Addendum 2

March 9, 2022

Addition and Renovation to: Norris Middle School
 5 Norris Square
 Norris, TN 37828

Job Number: 210042.04

MBI logo, professional seal of Christopher B. Trego, project information, revision information, and sheet title 'CIVIL NOTES & LEGEND'.

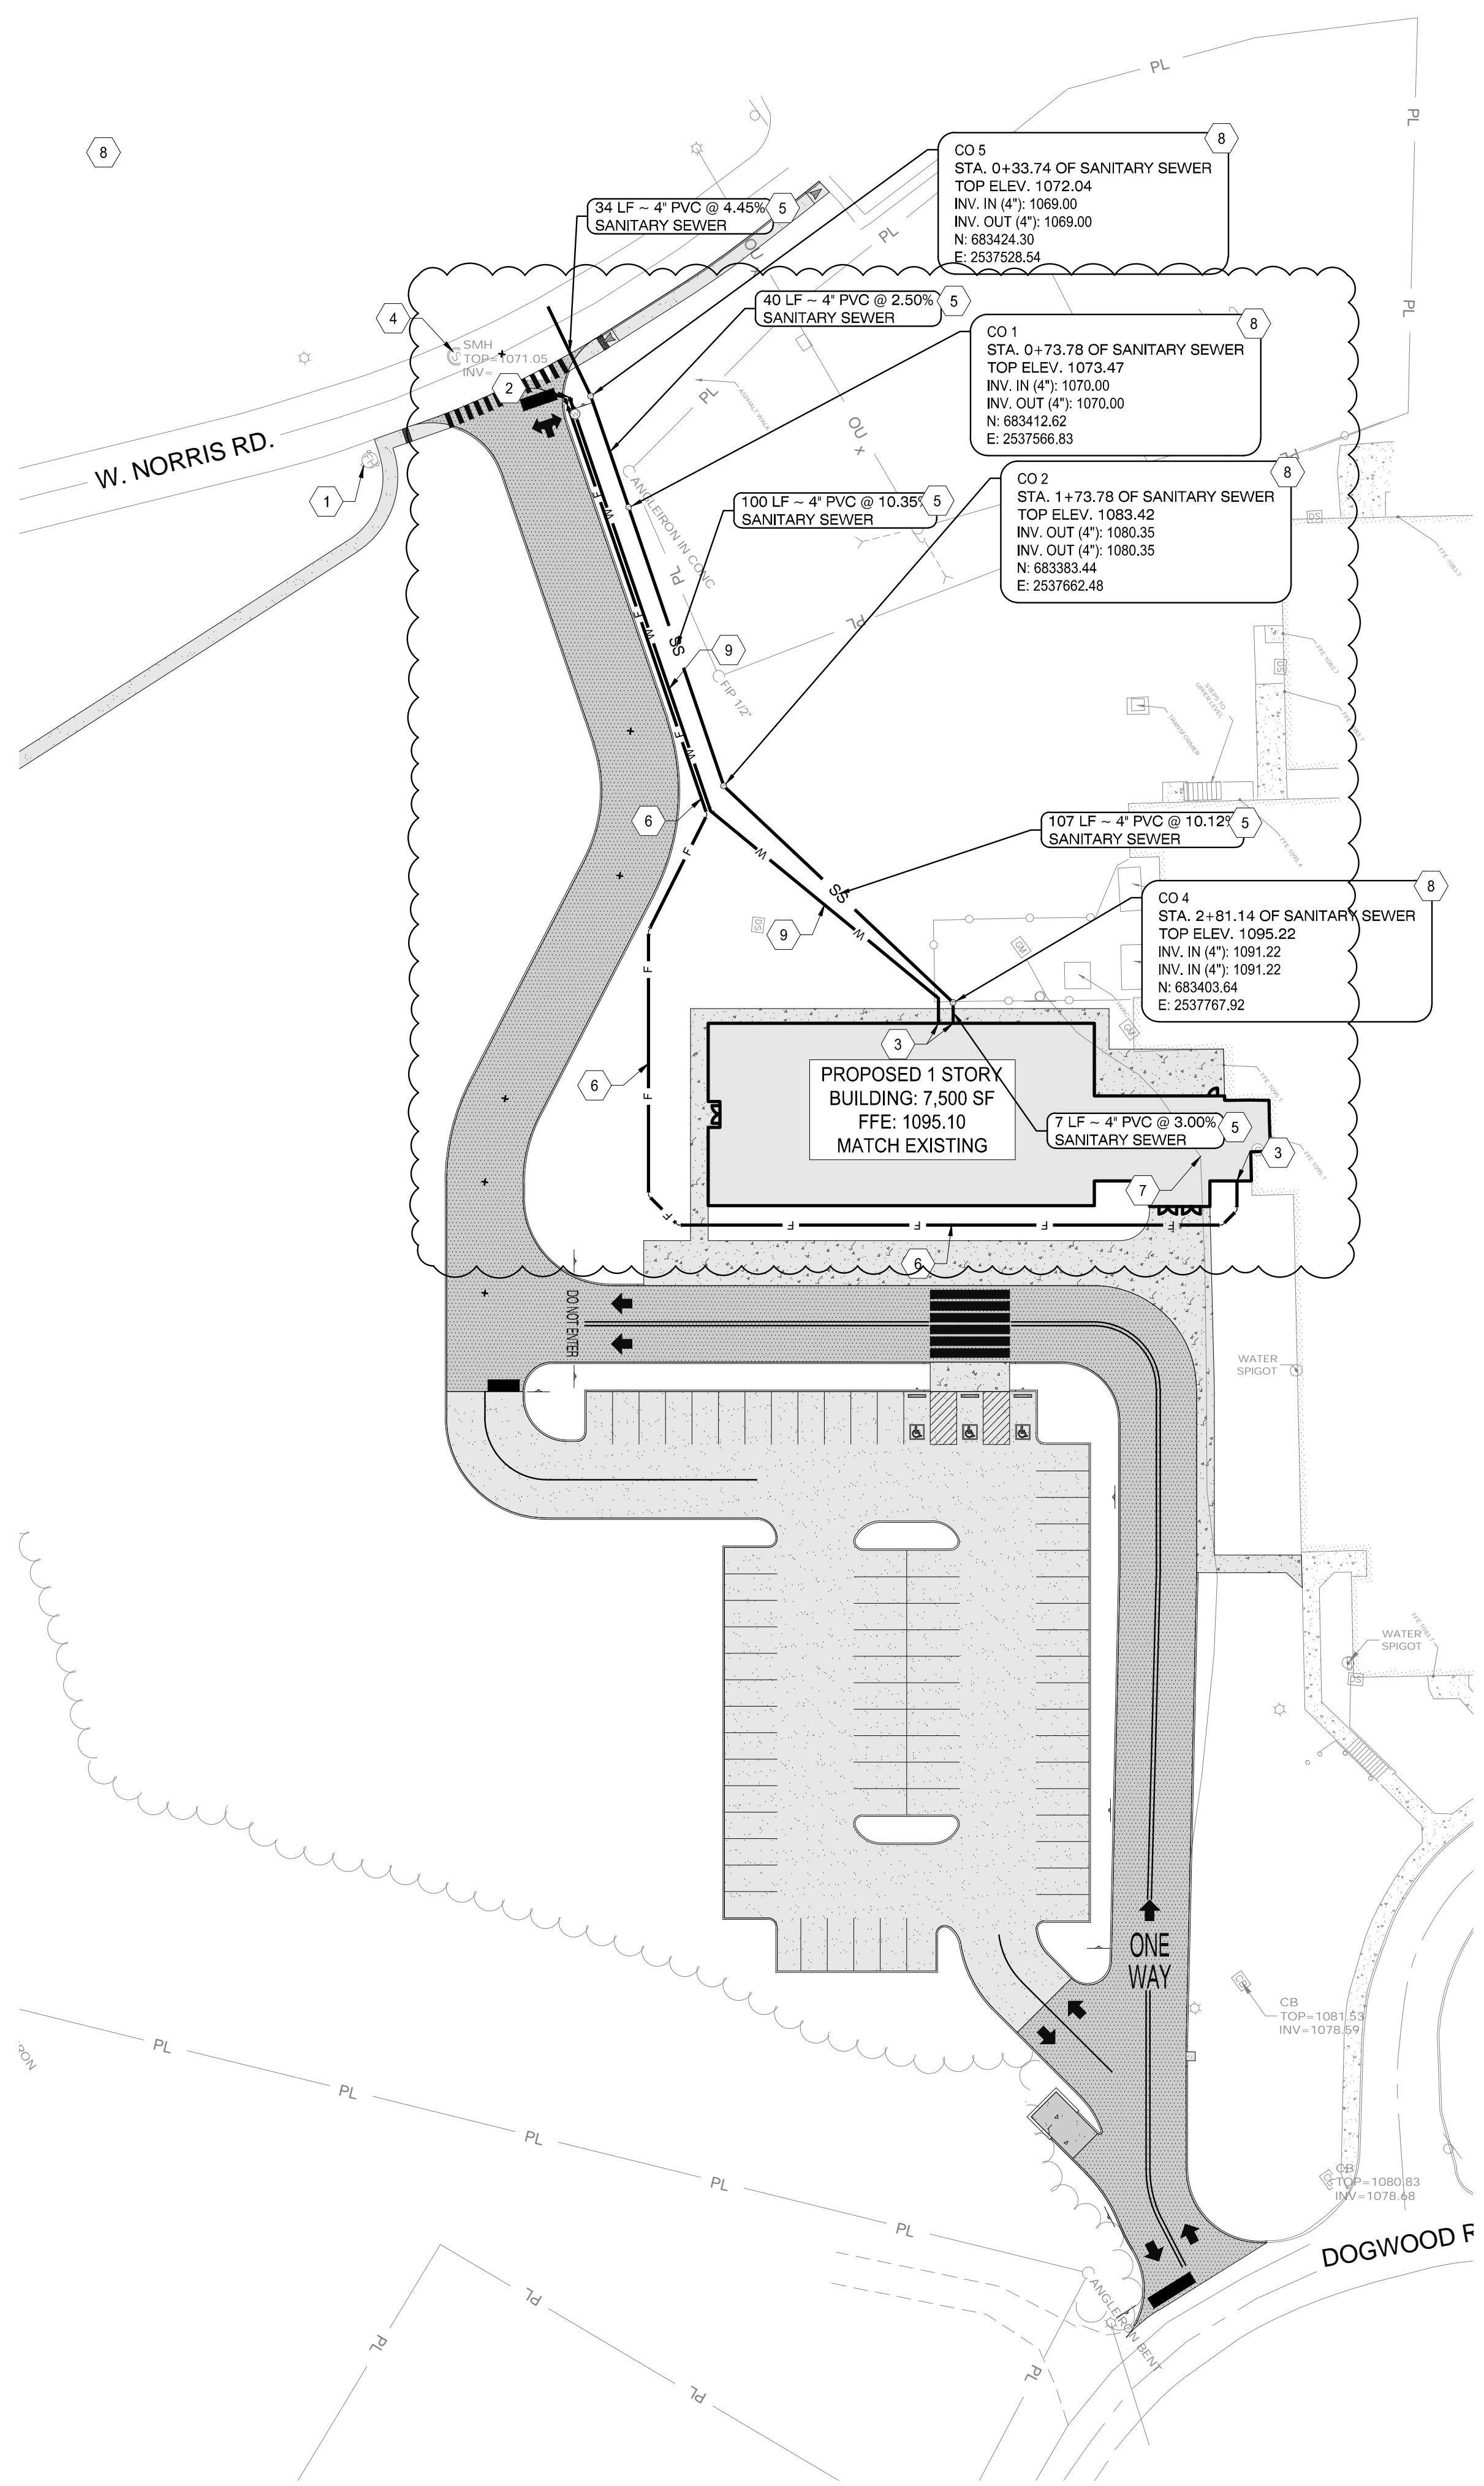
4. **CIVIL** - Reference Sheet C001, utility note #11 calls for fire line to be ductile iron, however C500 utility plan #6 calls for PVC. Please verify the site fire line is to be C-900 PVC.

Answer and drawings/specs included: Note 11 on C001 has been removed and Sheet C001 has been revised. The fire line should be PVC C-900 as specified on the plans.

SITE UTILITY PLAN

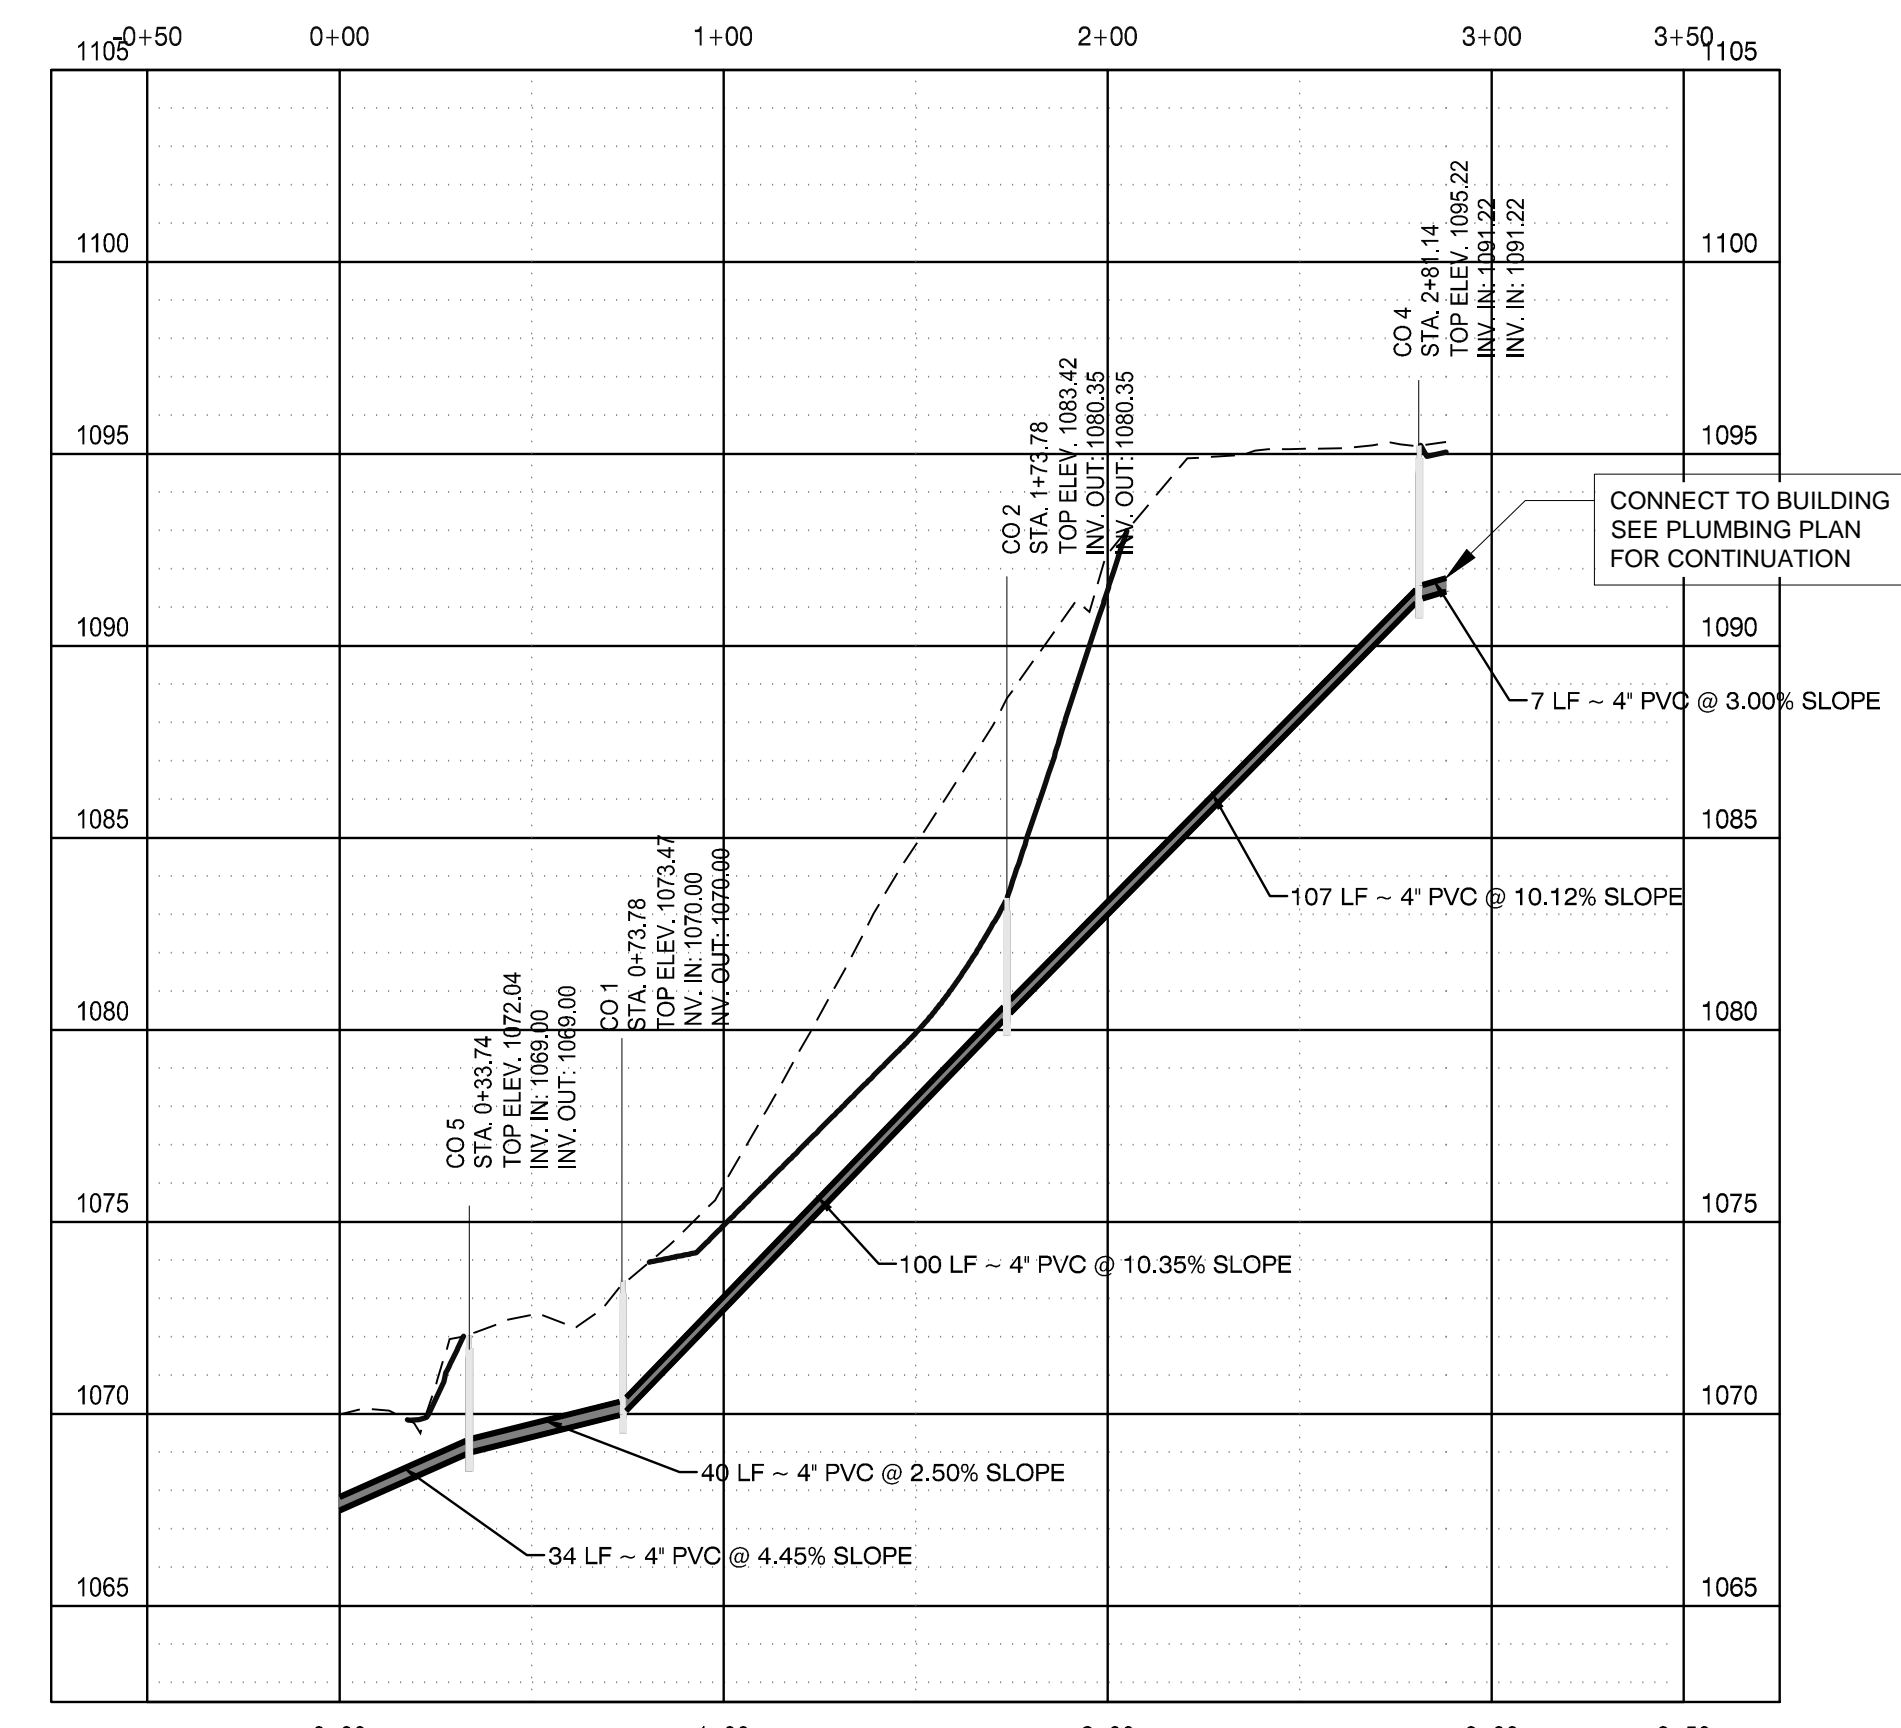
10. **FIRE PROTECTION** - You cannot run a fire line under a building like it's shown on the FP drawings unless you want to Arch the footings, install valves and put this pipe in an open trench with a grate across it.

Answer and drawings/specs included: Fire line will be routed around the building to the sprinkler room. See sheets C500 and FP101.

SHEET INFORMATION
SHEET ISSUED: 02/04/2022
DESIGNED BY: CMG
DRAWN BY: KEF
REVIEWED BY: CMG
SHEET TITLE: DOOR SCHEDULE, WINDOW TYPES, AND DETAILS
SHEET NO.: A201

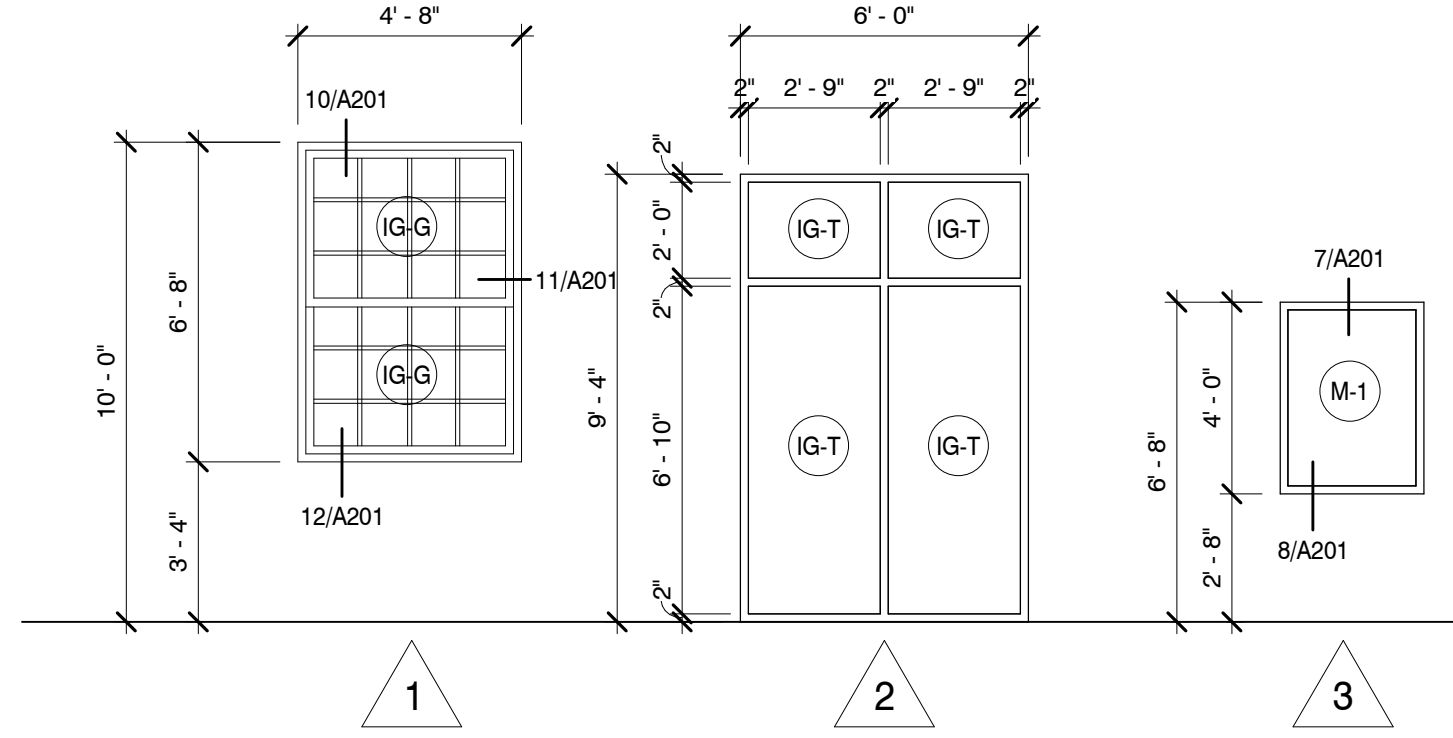
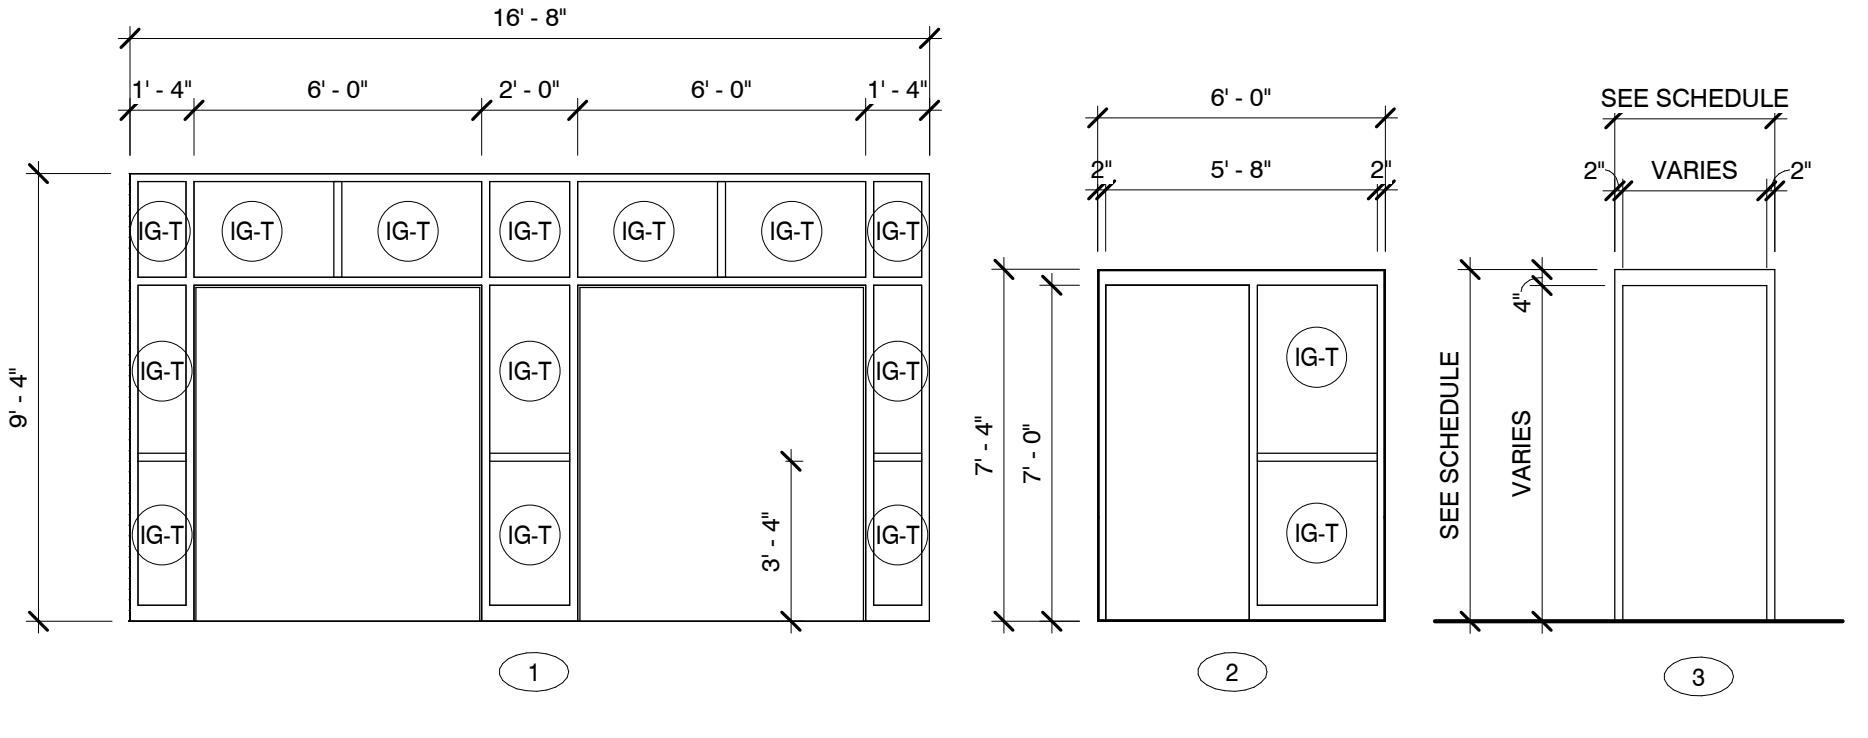
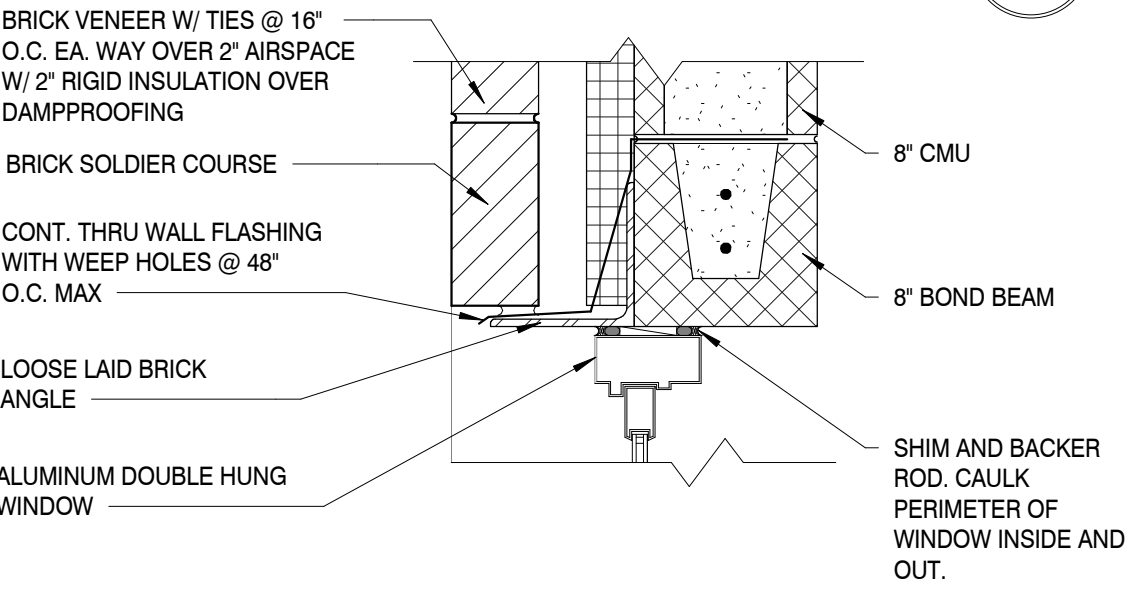
11. **ARCH** - The openings specified in door hardware set 1 (08 71 00) are going to require additional hardware in order to function properly and meet egress requirements. We would like to

propose breaking hardware set number one into the five different sets (1A-1E) per the attachment.

Answer and drawings/specs included: Proposed hardware sets accepted. Please see updated specification 08 71 00 – Door Hardware, and Drawing sheet A201.
